**August 21, 2014
BOARD OF COUNTY COMMISSIONERS
ORANGE COUNTY, FLORIDA**

**ADDENDUM NO. 8
IFB NO. Y14-748 PH
ORANGE COUNTY EASTERN WATER RECLAMATION FACILITY
PHASE V AND CENTRIFUGE DEWATERING IMPROVEMENTS**

C-140
52 OF 527

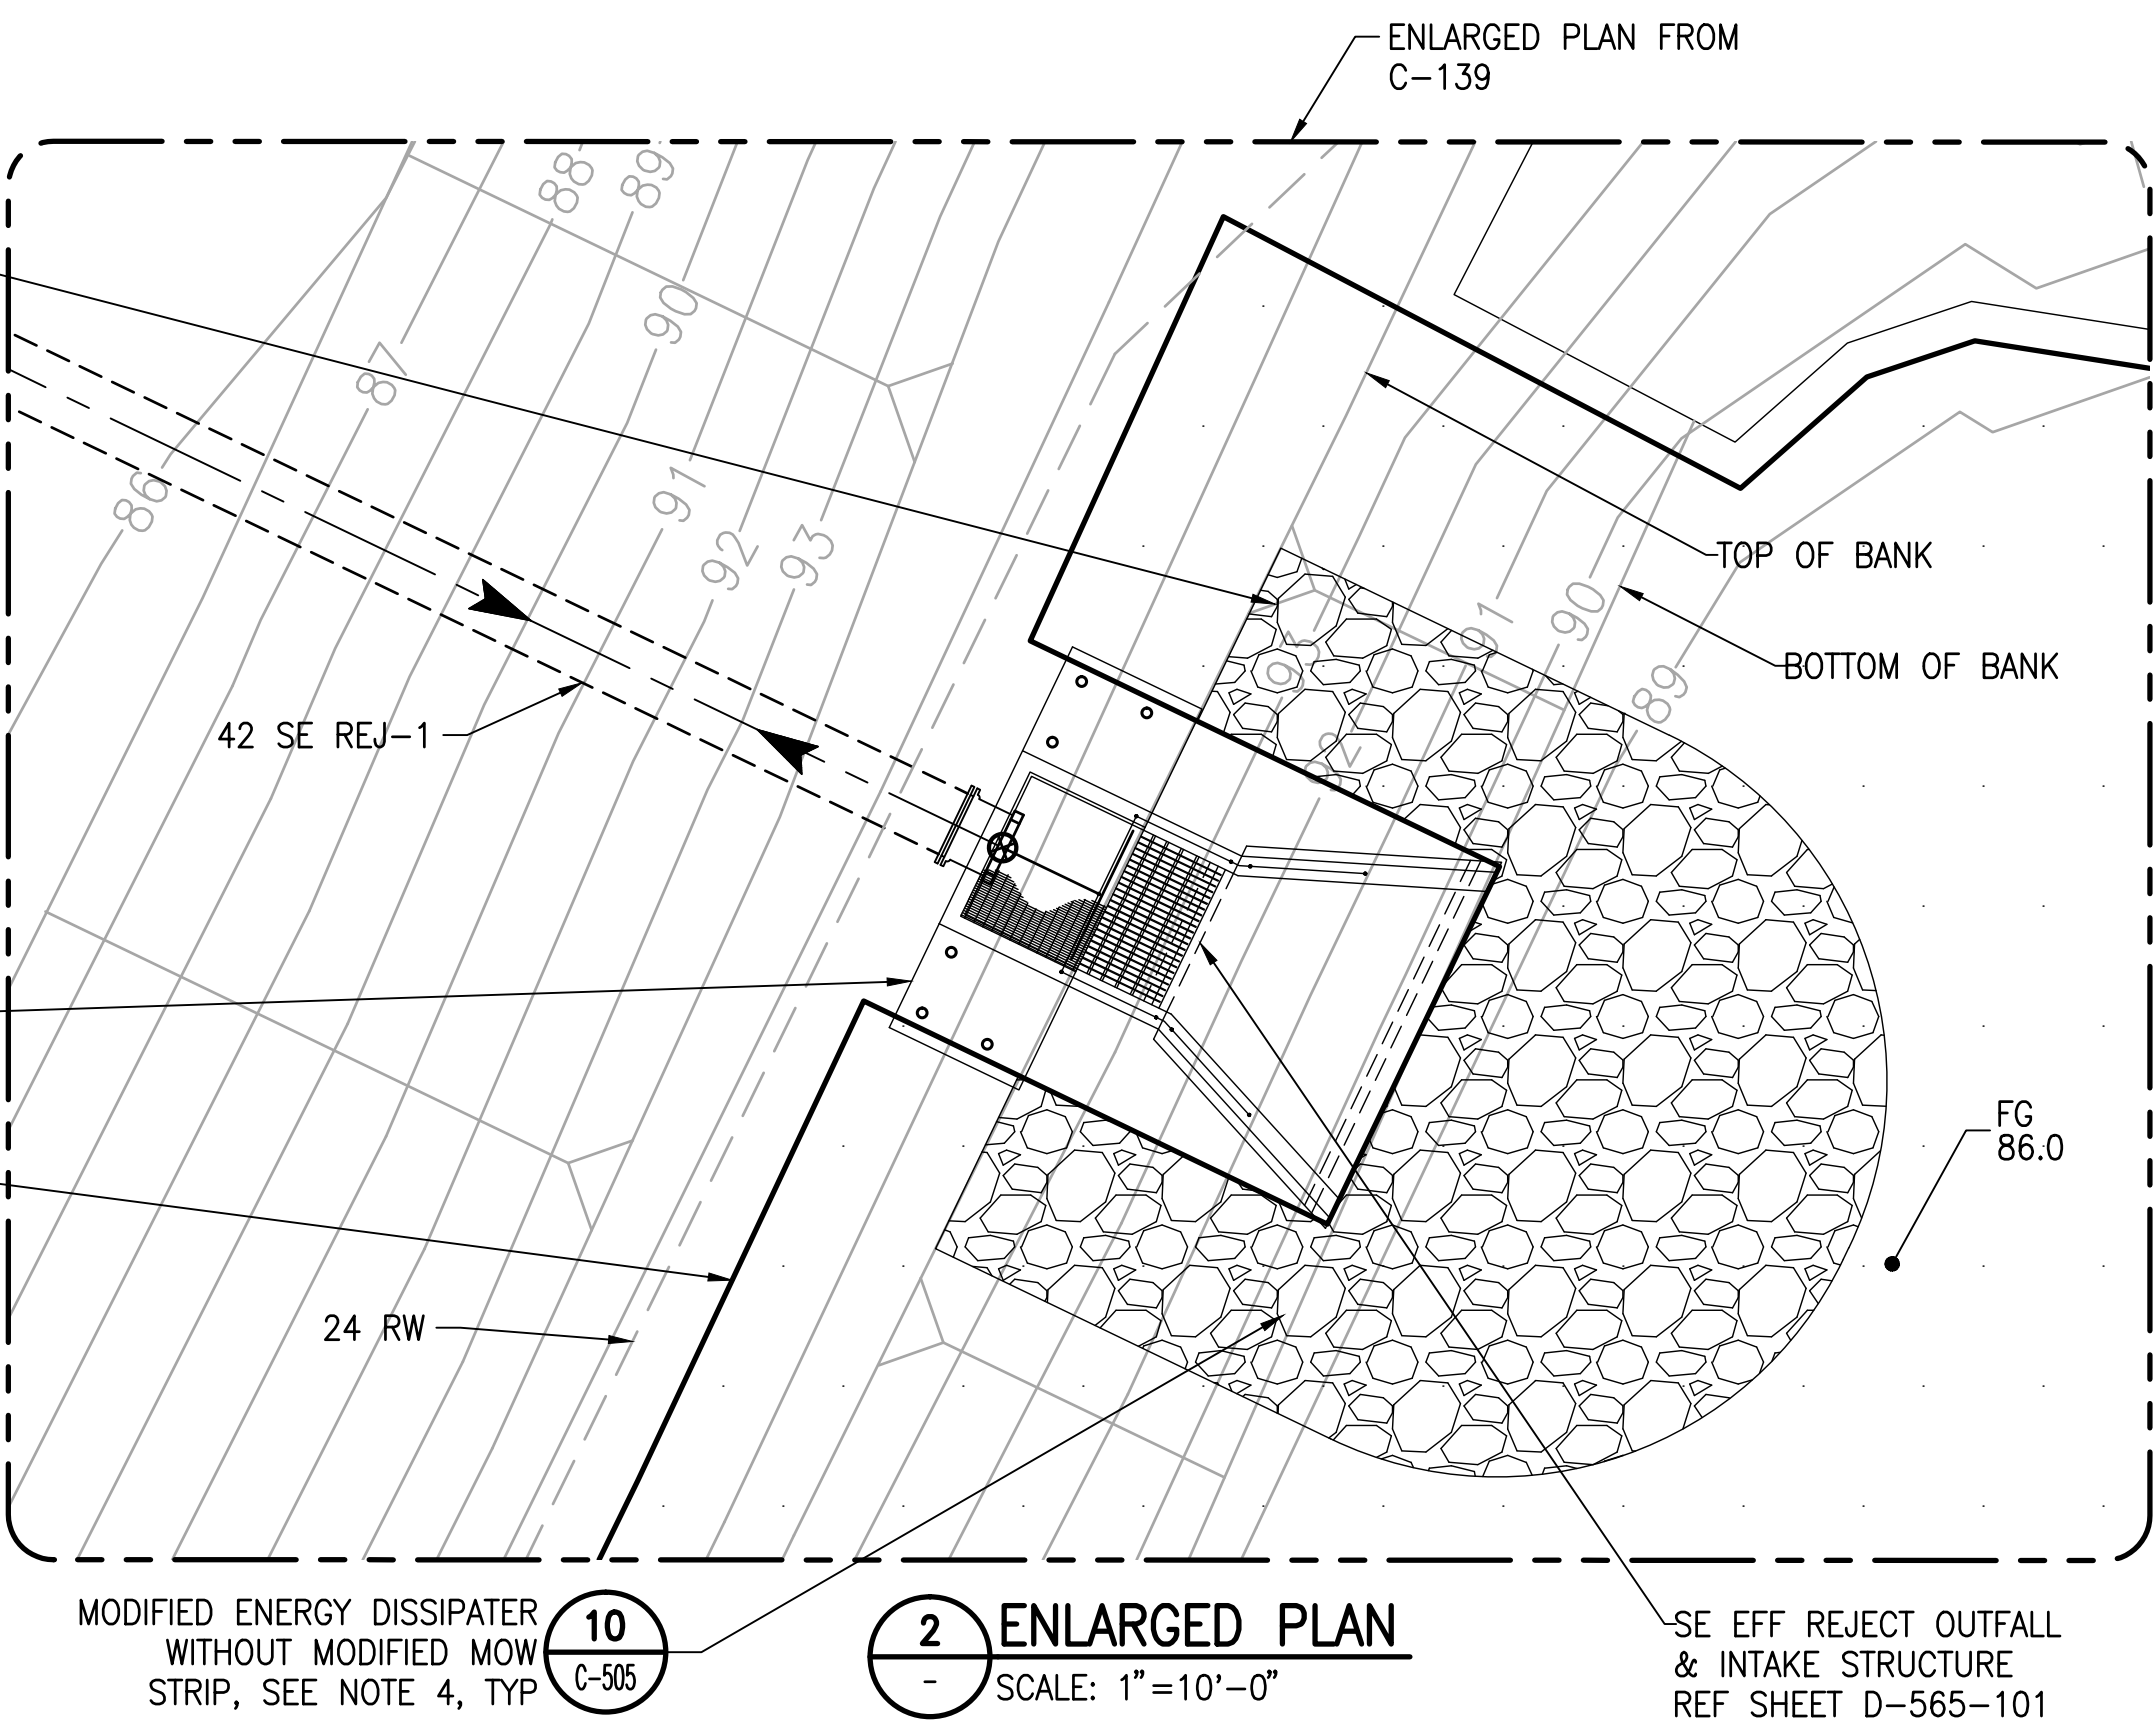
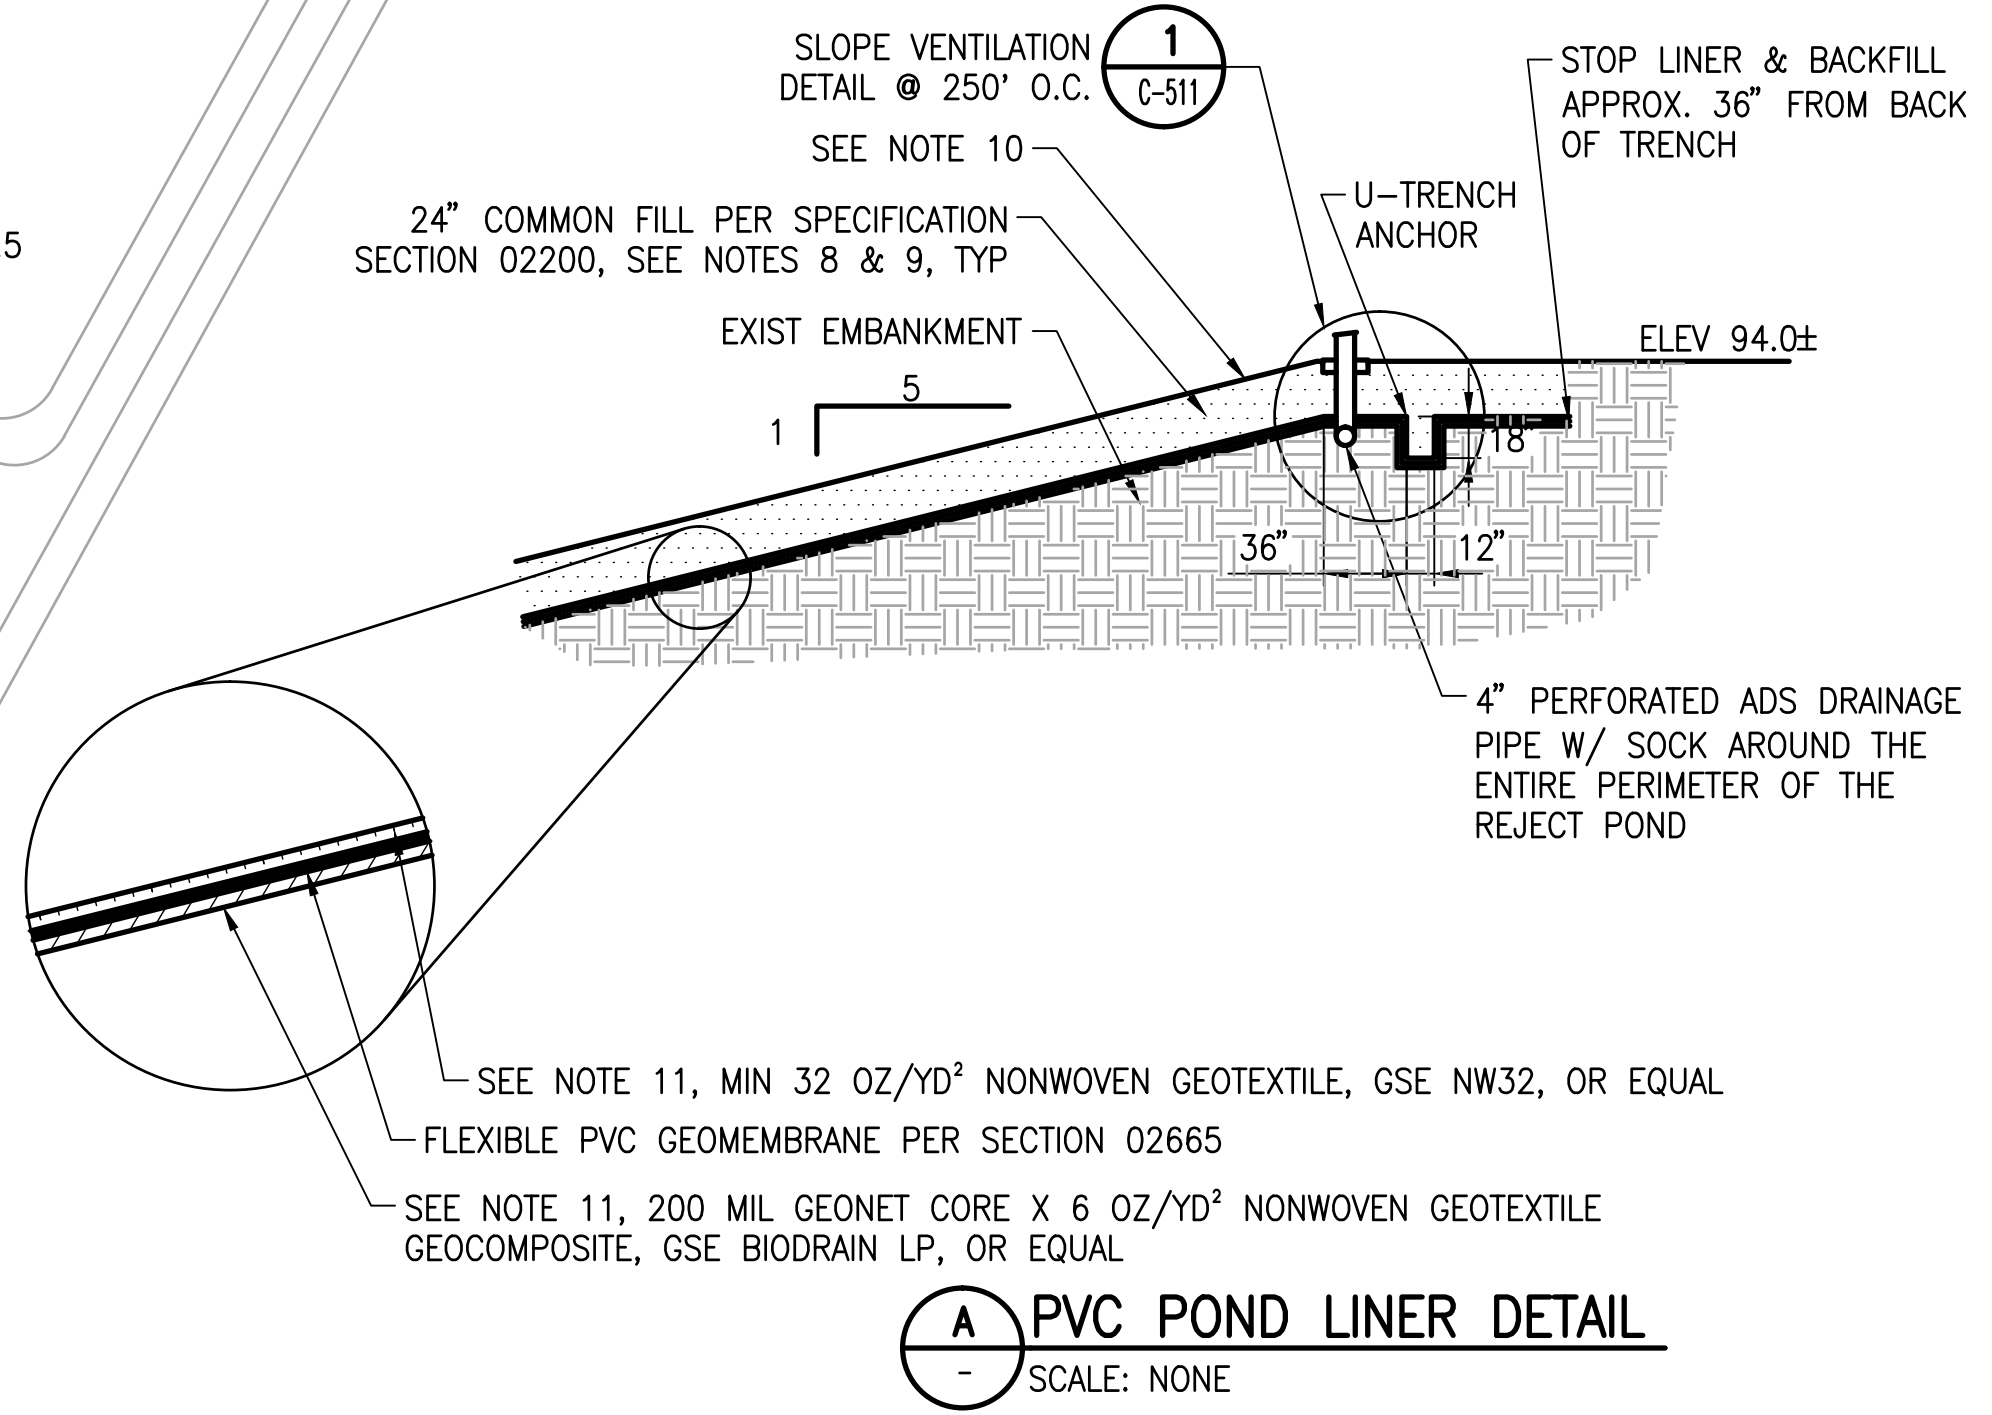
1. In reference to Bid Package A, please see the questions below from a potential supplier/vendor for the geocomposite product noted on revised Drawing C-140, Detail A as issued in Addendum 6.

- a. The noted material GSE HyperNet Geonet is not a geocomposite. A geocomposite will have either one layer of geotextile bonded to one side of the geonet material to form a single-sided geocomposite, or a layer of geotextile bonded to each side of the geonet to form a double-sided geocomposite. Please clarify if the geosynthetic material is to be a geocomposite or a geonet?

- b. Also, an 8 oz/sy nonwoven fabric would be geotextile, not geogrid. The continued reference to geogrid is confusing and misleading. Please clarify if the geosynthetic material above the PVC liner is to be geotextile or geogrid?

*Please reference Drawing C-140, Section A with the following revision;
~~SEE NOTE 11. GEOCOMPOSITE MATERIAL, 250 MIL GSE HYPERNET
GEONET, OR EQUAL SEE NOTE 11. 200 MIL GEONETCORE X
60Z/YD² NONWOVEN GEOTEXTILE GEOCOMPOSITE, GSE
BIODRAIN LP, OR EQUAL (Attachment)~~*

*Please reference Drawing C-140, Section A with the following revision;
~~SEE NOTE 11. 8 OZ NON-WOVEN GEOGRID FABRIC, TYPAR 3801,
OR EQUAL SEE NOTE 11. MIN 32 OZ/YD² NONWOVEN
GEOTEXTILE, GSE NW32, OR EQUAL (Attachment)~~*
